## **Hartmann Road/Valley Oaks Development Intersection Analysis**

**MEMORANDUM**

Subject: Valley Oaks Development, MUP 19-09  
Highway 29 & Hartmann Road, Middletown  
APN: 013-030-07

Valley Oaks Project, Grocery Outlet  
1-LAK-29-9.87  
MUP 19-09

**SITE DEVELOPMENT PLAN**  
 SCALE 1"=40'  
**APN: 014-260-21**

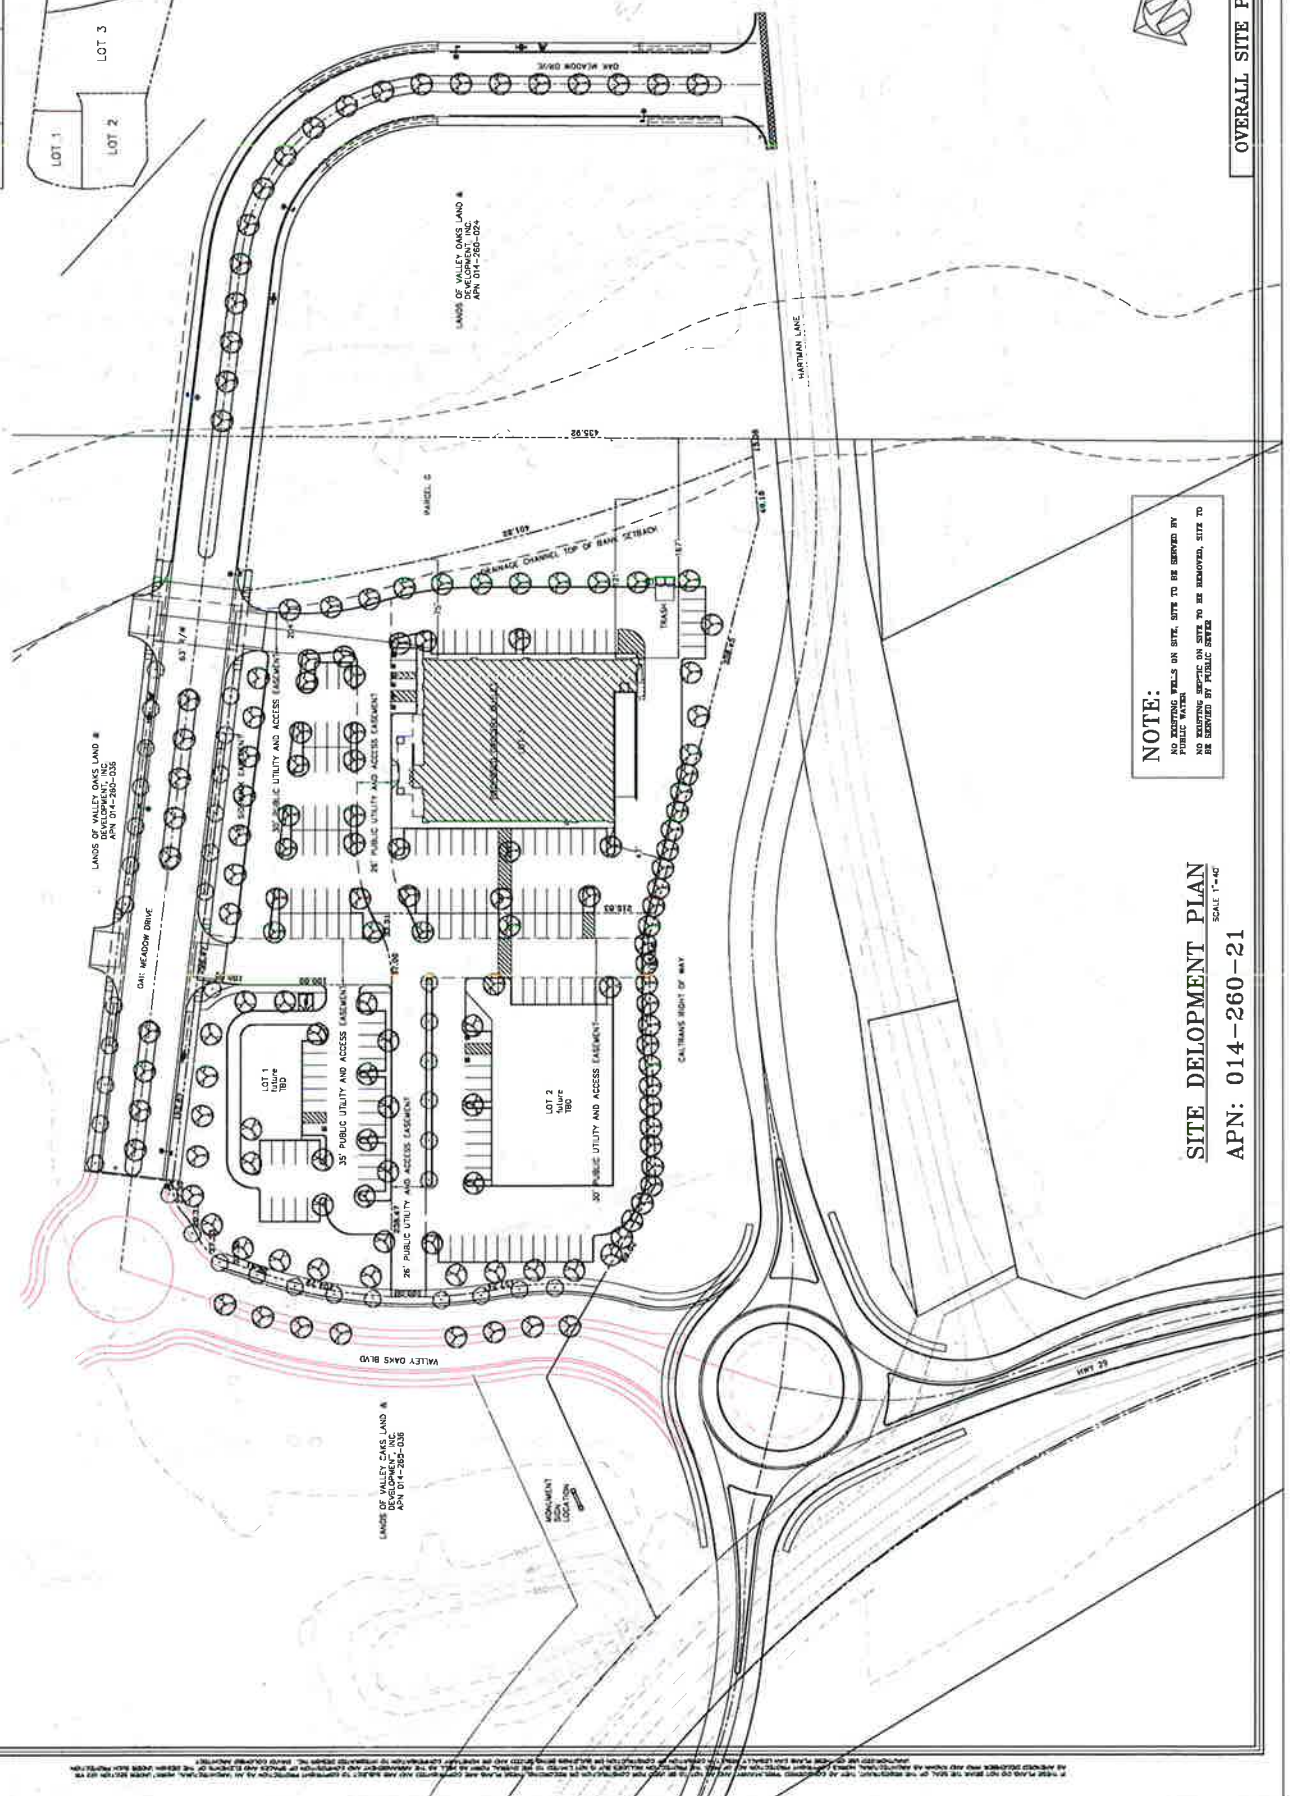
1. The owner has submitted improvement plans to DPW for the construction of Oak Meadow Drive. The "Site Development Plan" shows Valley Oaks Blvd. connecting to the Hartmann Road/SR 29 roundabout to provide access to this proposed development. If this is not the intention of this particular development then Valley Oaks Blvd. should be noted as a future access with a future connection to the roundabout.

2. The Site Development Plan does not indicate whether the proposed access roads will be contained within a public right of way or easement. If it is not proposed that these roads be public, then Public Works would not have jurisdiction over the private roadways.

3. The building pads are shown as "Lots" 1, 2 & 3. Does this proposal include a parcel map or subdivision map?
4. The Intersection Analysis prepared by W-Trans concludes that "While a left-turn lane is not warranted on Hartmann Road at the intersection with the new project street with just the traffic generated by the proposed Grocery Outlet use, a left-turn lane is warranted and recommended with the development of any additional land use that would generate traffic at the new intersection." A condition of approval should therefore be included requiring construction of the left-turn lane when any additional traffic generators are developed/approved.
